SUBJECT: Forwards responses to Auxiliary Sys Branch Questions.
 010.043 & 010.054 & Instrumentation & Control Sys Branch
 Questions 031.117, 031.118 & 031.128. Responses will be
 incorporated into FSAR amend.

Subject: NUCLEAR PROJECT NO. 2
RESPONSES TO REQUESTS FOR INFORMATION

Enclosed are sixty copies of the responses to Auxiliary Systems Branch Questions 010.043 and 010.054 and Instrumentation and Control Systems Branch Questions 031.117, 031.118 and 031.128.

HACS P&ID

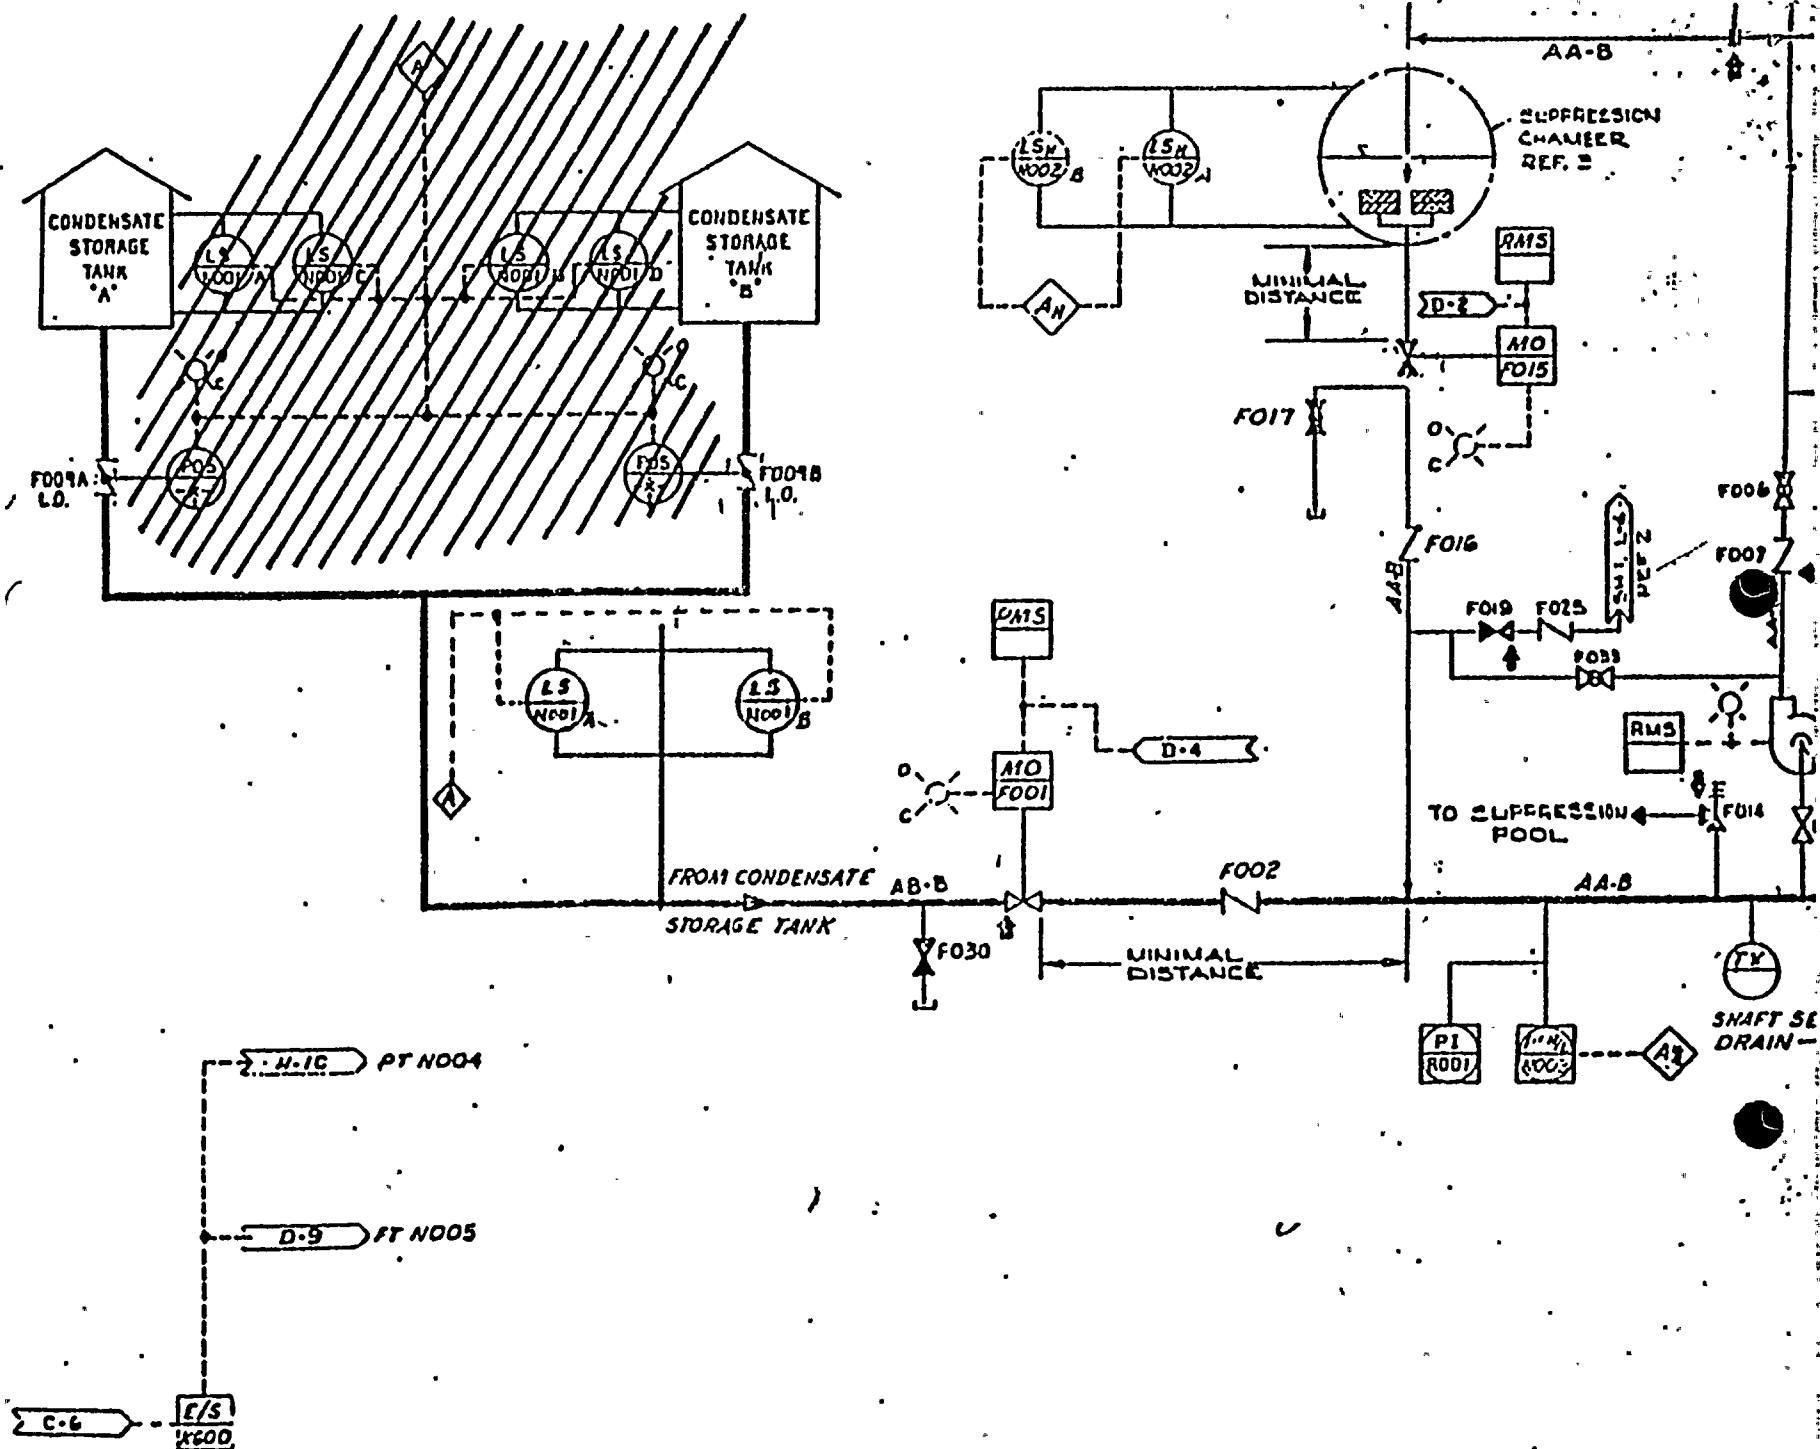
Figure 7.3-7 of the FSAR indicates that there are two condensate storage tanks, each with a manually operated discharge valve. The functional control diagram (i.e., Figure 7.3-8) illustrates, and the text discusses, the interlock between the condensate storage tank and the suppression pool suction valves which is intended to provide assurance that the high pressure core spray (HPCS) system pump has an acceptable supply of water at the suction inlet. However, if both manual discharge valves were to be closed, the purpose of this interlock would be defeated. Accordingly, provide justification in section 7.3.1.1.1 for the omission of manual discharge valve position switches as initiators in the HPCS pump suction control logic.

FSAR Figure 7.3-7 has been changed to Figure ^{manual}6.3-1 and Figure 7.3-8 has been changed to Figures 7.3-8a, 7.3-8b, and 7.3-8c. These figures have been revised to delete the ~~manual~~ discharge valve position interlocks. These interlocks were originally provided (when the condensate storage tanks level switches were physically mounted on the tanks) to prevent premature transfer of the HPCS suction to the suppression pool when one of the tanks was out of service (drained) giving a false transfer signal.

Figure 6.3-1 has been revised to indicate the level switches on a Class 1 standpipe in the Reactor Building on the condensate supply line to HPCS which is downstream of the manual suction valves. (These valves are locked open during normal operation.) With this modification, valve position interlocks are no longer required. FSAR Section 7.3.1.1.1 has been revised to correctly describe this modification.
